**RE: Docket No. UE 319–In the Matter of PORTLAND GENERAL
ELECTRIC COMPANY, Request for a General Rate Revision.
(Net Variable Power Costs (NVPC))**

Enclosed for filing is Staff Opening Testimony (NVPC) in UE 319,
together with a Certificate of Service and UE 319 Service List.

Figure 1

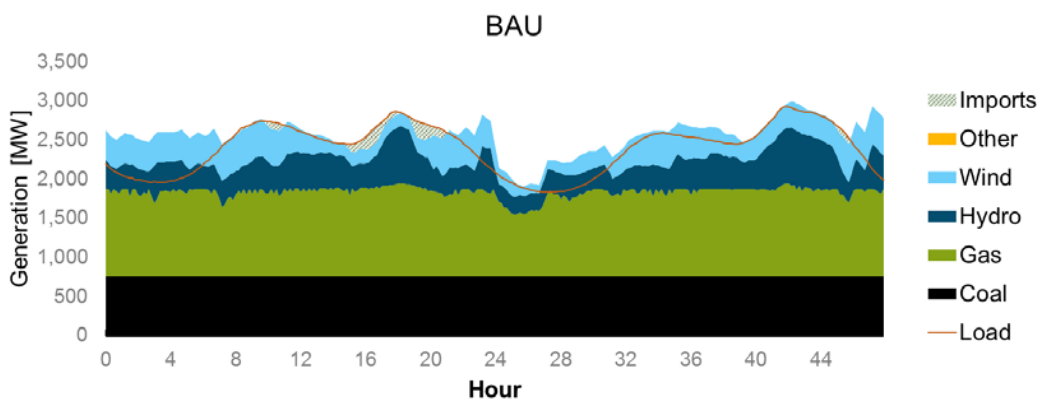
9 In order to analyze if this loss of granularity had an impact on the benefit
 10 estimation, Staff utilized a chart in the E3 study that shows an estimation of
 11 PGE's dispatch without involvement in the EIM. Ideally, this estimation would
 12 closely mirror the actual PGE dispatch and the MONET estimation. Below is
 13 E3's dispatch estimation for December 12th and 13th of 2018, followed by
 14 2016's actual dispatch for those days and MONET's estimation of the same
 15 days in 2018.

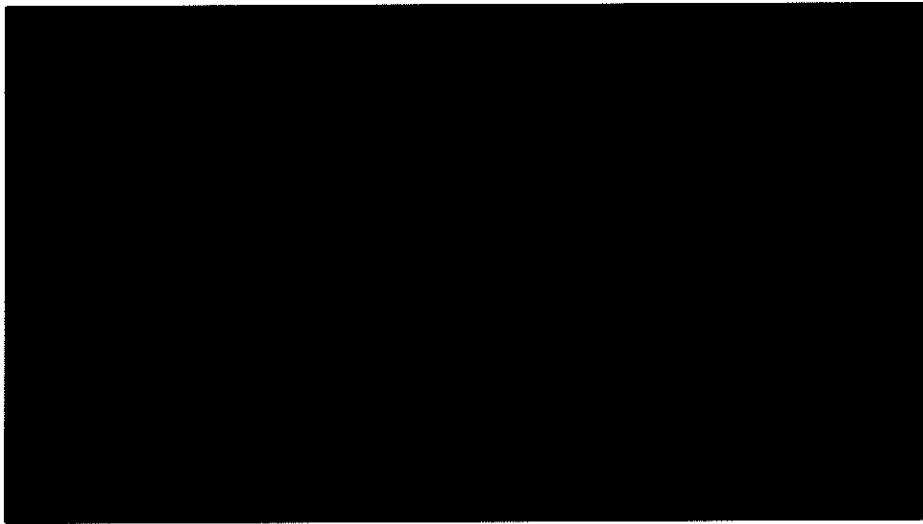
A. Table 6 below calculates Staff's adjustment. Lines 1 through 3 provide historic revenues. Staff's forecast is equal to the three year average of revenues. PGE's historic transmission revenues are summarized below. Staff's adjustment equals Staff's forecast less PGE's forecast. PGE's filing includes [BEGIN CONFIDENTIAL] [REDACTED] [END CONFIDENTIAL] in transmission revenue.⁴⁹ This results in an adjustment of [BEGIN CONFIDENTIAL] [REDACTED] [END CONFIDENTIAL].
